COPPERSTRING EIS

Attachment F - Vegetation Clearing Works plans

Dajarra Road to Mount Isa

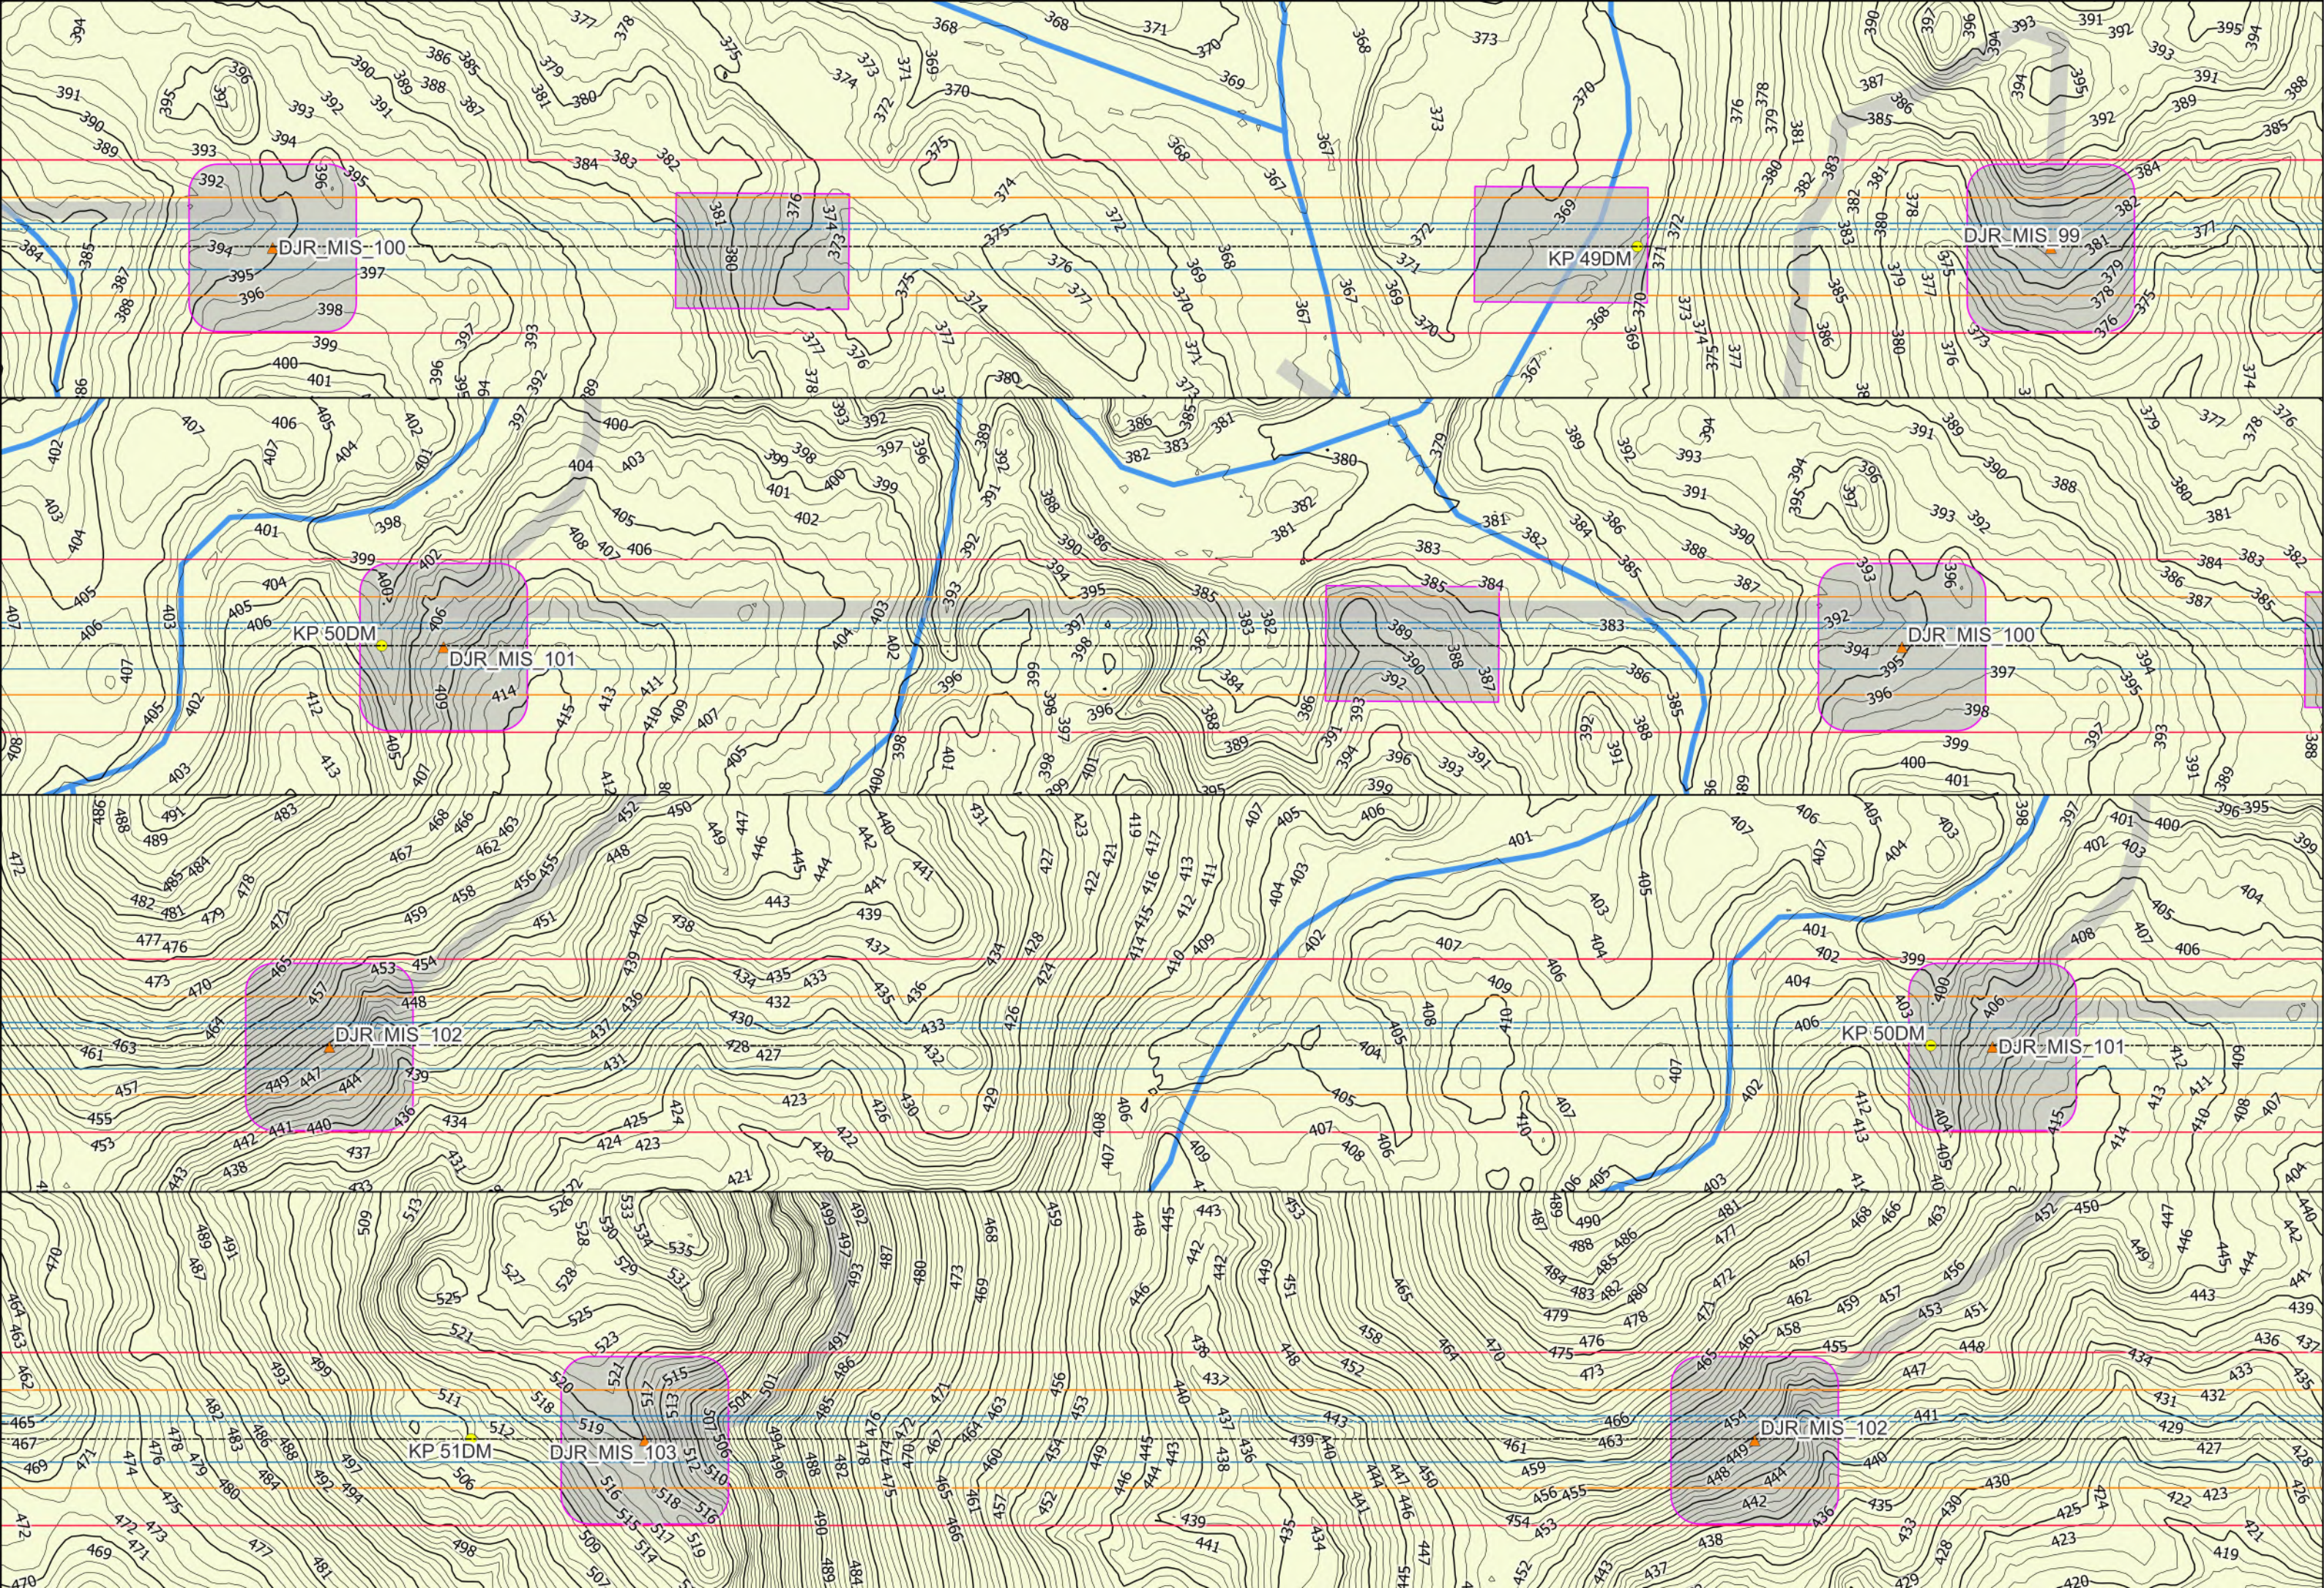
Average canopy height of 10m within this section of vegetation utilised in the calculation of conductor clearance

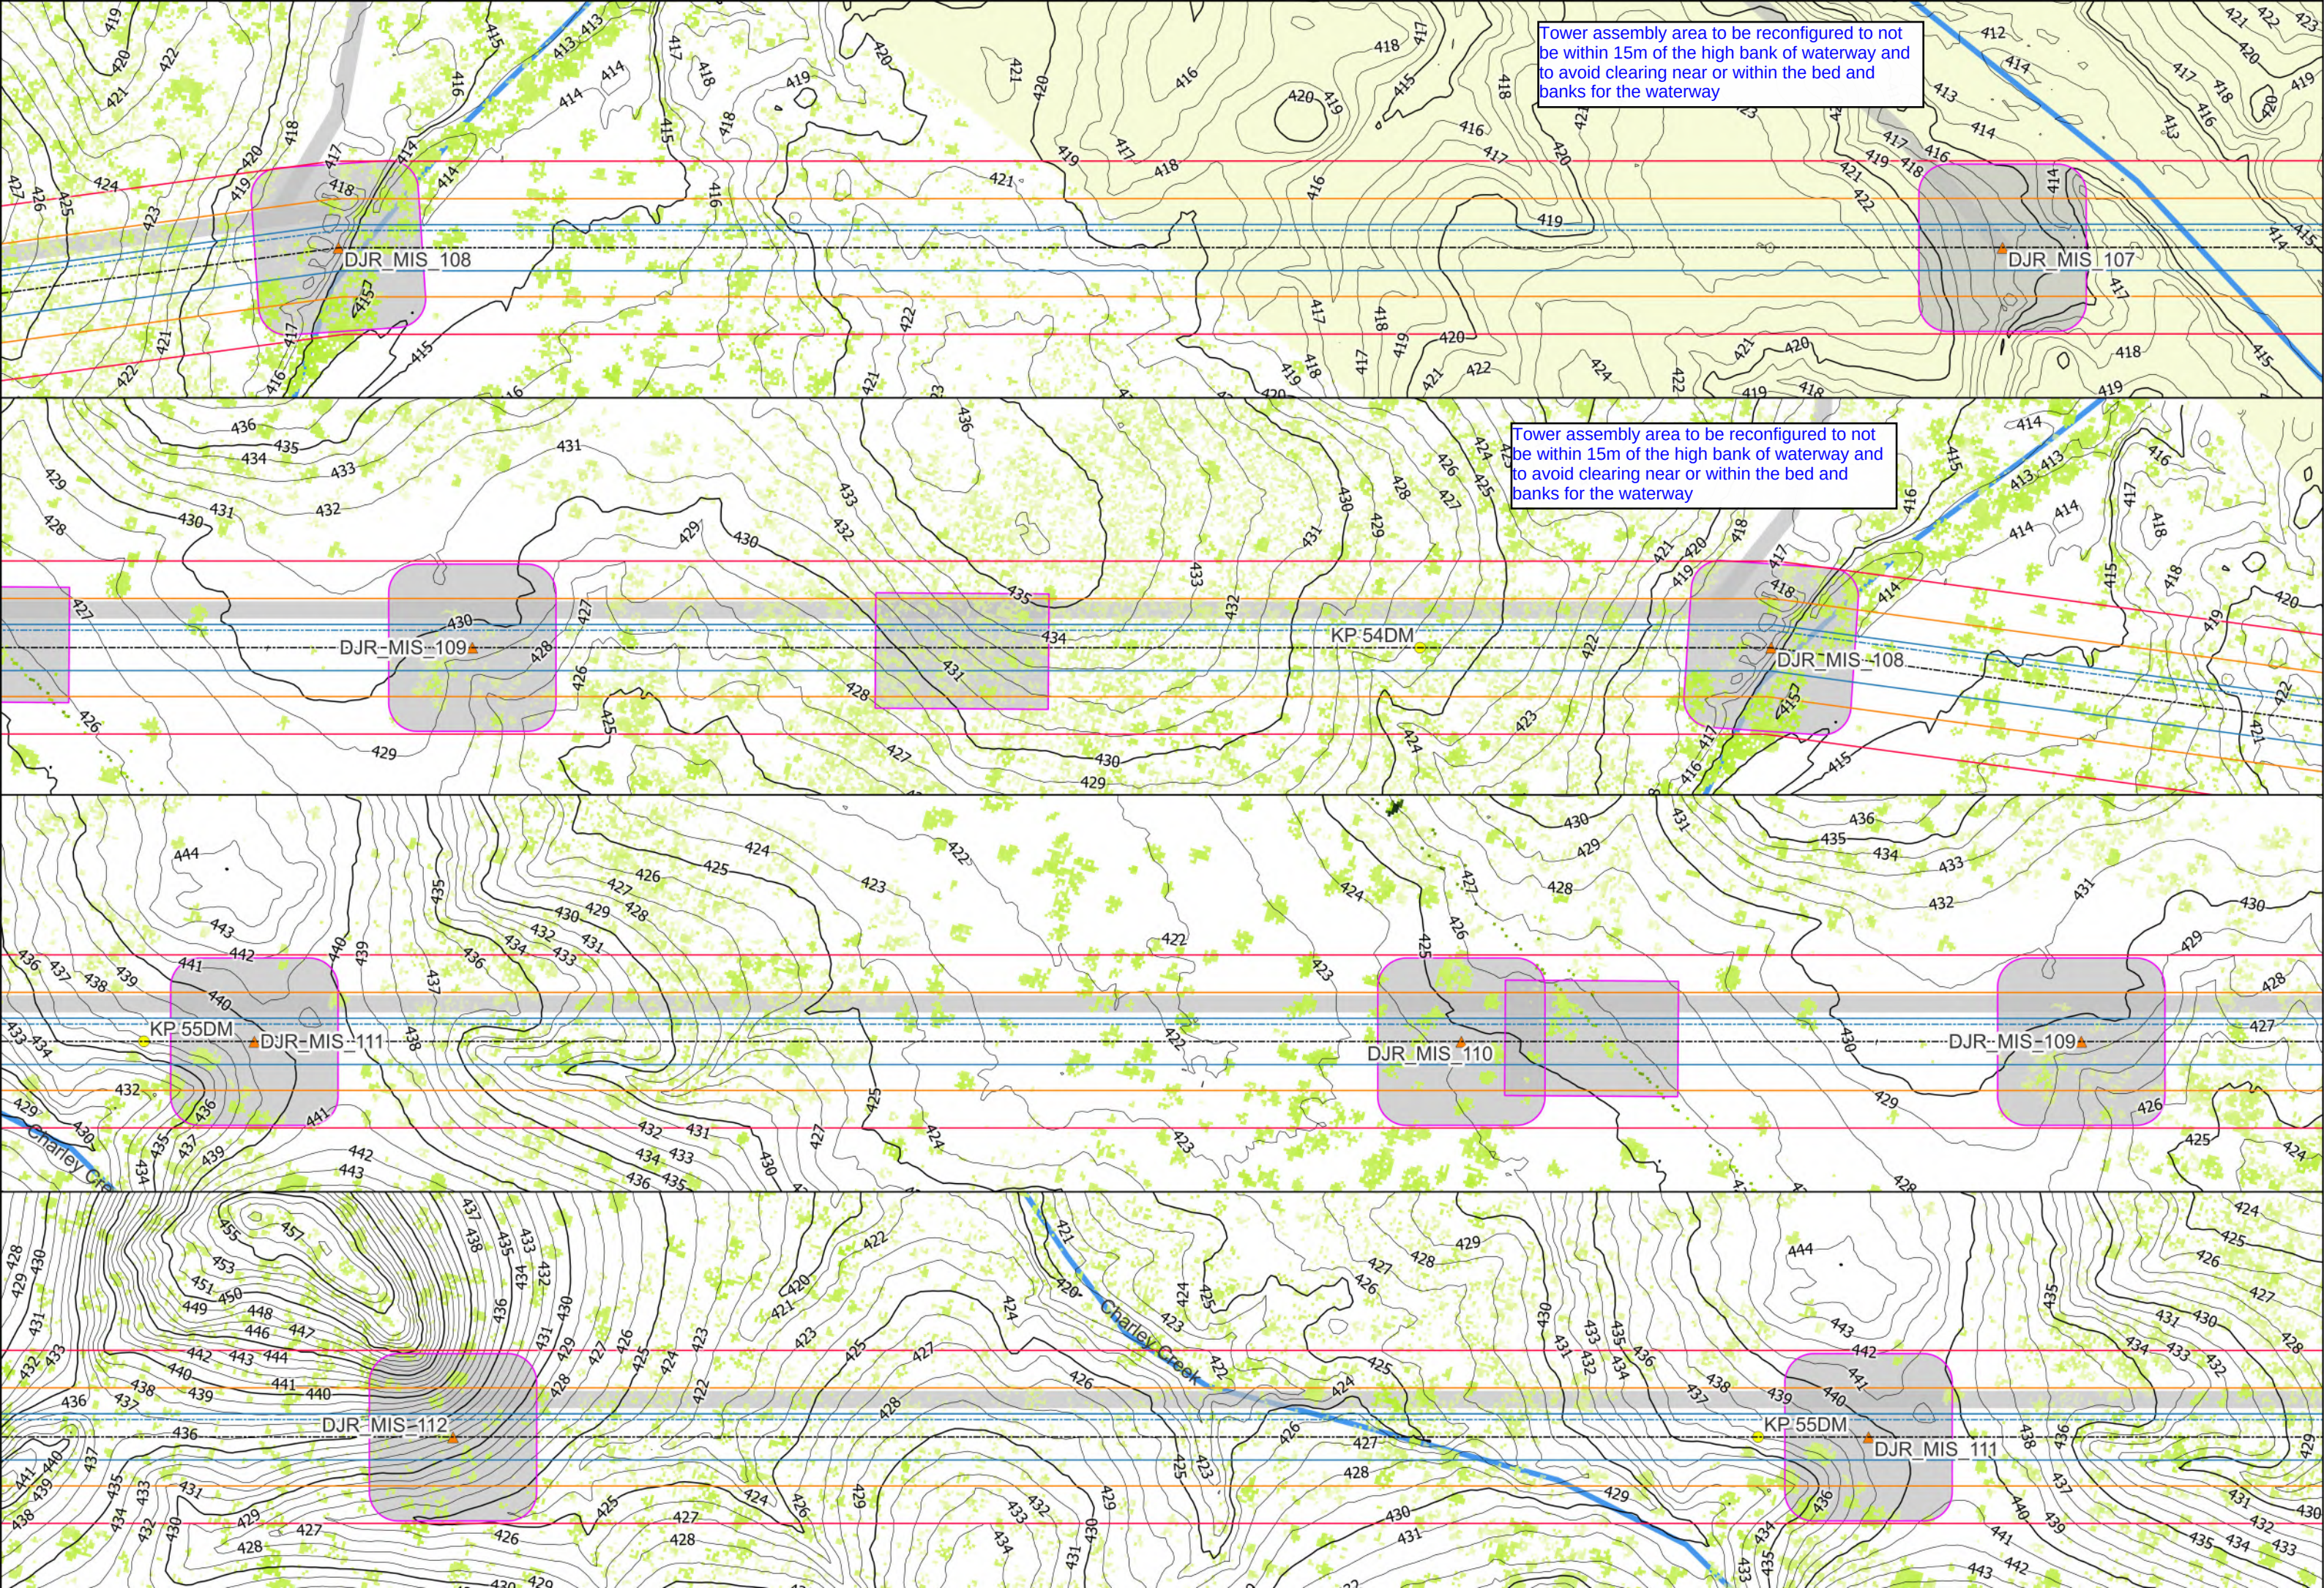
Tower assembly area to be reconfigured to not be within 15m of the high bank of waterway and to avoid clearing near or within the bed and banks for the waterway
